TPB Ref.: A/NE-TKL/843

**Temporary Warehouse for Storage of Metal for a Period of 3 Years and Filling of Land at Lot 554 S.A ss.2 (Part) in D.D.77, Ng Chow South Road, Ta Kwu Ling, N.T.**

This letter intends to supersede our letter dated 29.7.2026. About 89% of the site (i.e. about 870m<sup>2</sup>) falls upon ‘Agriculture’ zone and about 11% of the site (i.e. about 110m<sup>2</sup>) falls upon ‘Residential (Group D)’ zone.

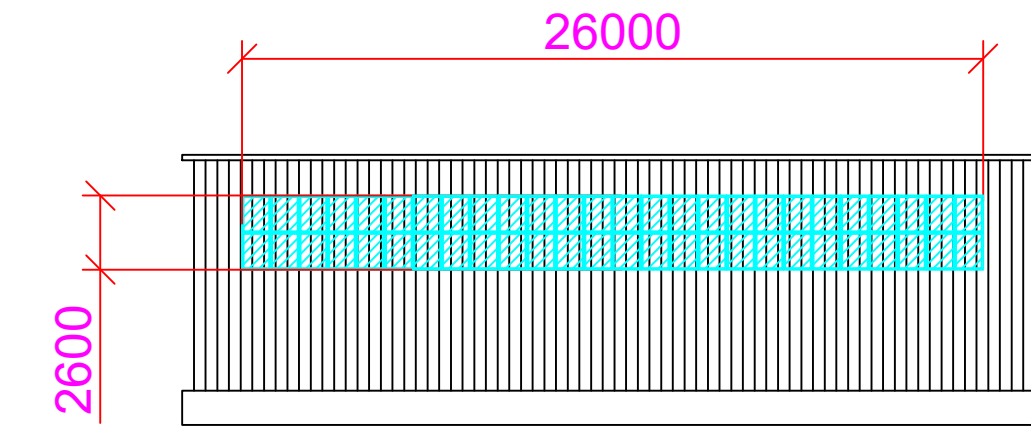
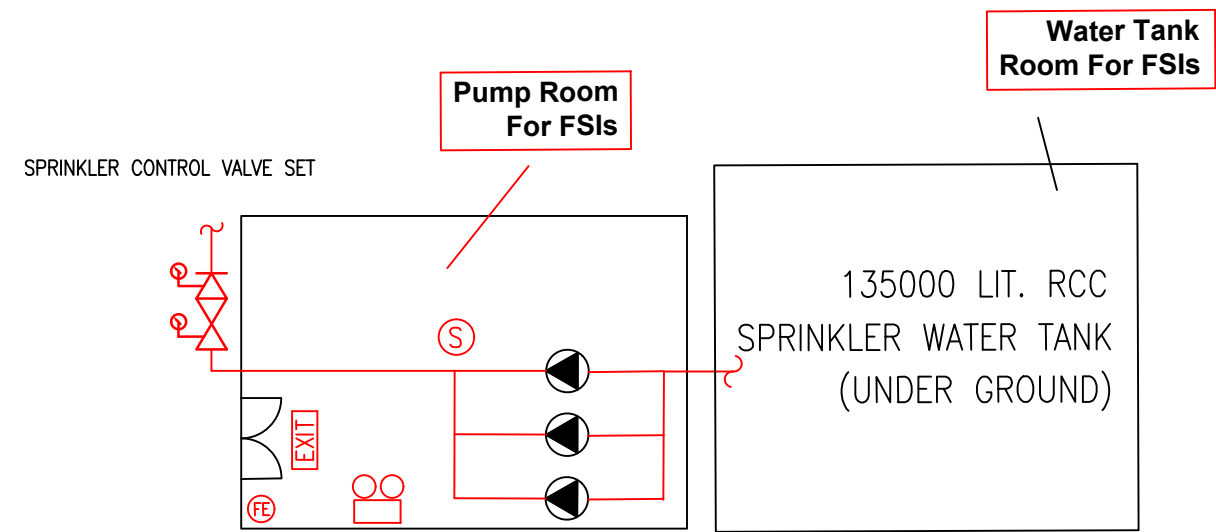
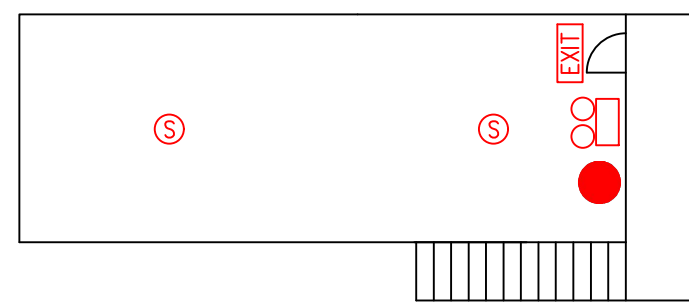
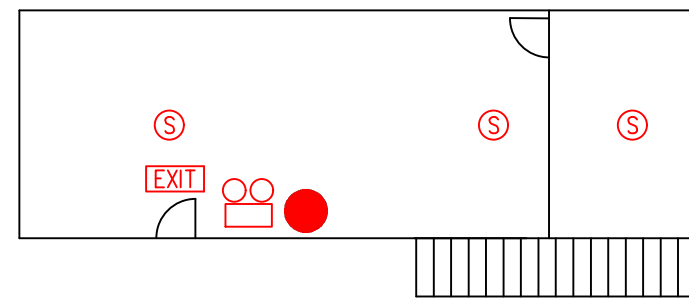
Our response to the comments of the Director of Fire Services is shown on the attached FSI plan.

As-built Site Paving Plan  
in 'Agriculture' Zone

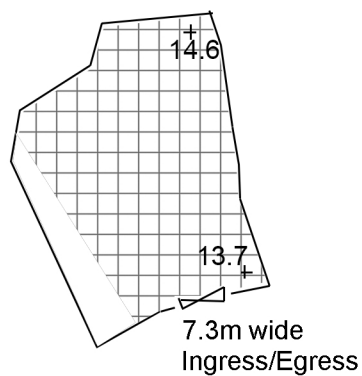
| <p>Form, it is understood that no further land filling be carried out within the Site. As such, please (i) retitle the drawing of your submitted “<b>Proposed</b> Site Paving Plan” to avoid confusion. Please (ii) confirm whether the entire site has been formed or only part of the site has been formed as shown on the “<b>Proposed</b> Site Paving Plan”, and (iii) supplement on the plan the current site level. (iv) What is the purpose of land filling?</p> | <p>S.16-III application form have been updated and attached below. The entire site has been formed. The As-built Site Paving Plans shows that only the portion of the site falls upon ‘Agriculture’ zone has been filled because land filling is required to be applied within ‘Agriculture’ zone. Although the portion of ‘Residential (Group D)’ has also been filled, it is not required to show on the As-built Site Paving Plan because land filling in ‘Residential (Group D)’ zone is not required to be applied.</p> <p>The current site level is shown on the As-built Site Paving Plan. The application site is formed to meet the operation needs of the warehouse.</p> |

| Sha Tin, Tai Po and North District Planning Office's comment                                                                                             | Applicant's response                                                                                          |
|----------------------------------------------------------------------------------------------------------------------------------------------------------|---------------------------------------------------------------------------------------------------------------|
| <ul style="list-style-type: none"><li>Is the application site currently being used as the applied use?</li><li>Based on P.8 of the Application</li></ul> | <p>The application site is currently used as the applied use.</p> <p>The drawing title and page 12 of the</p> |
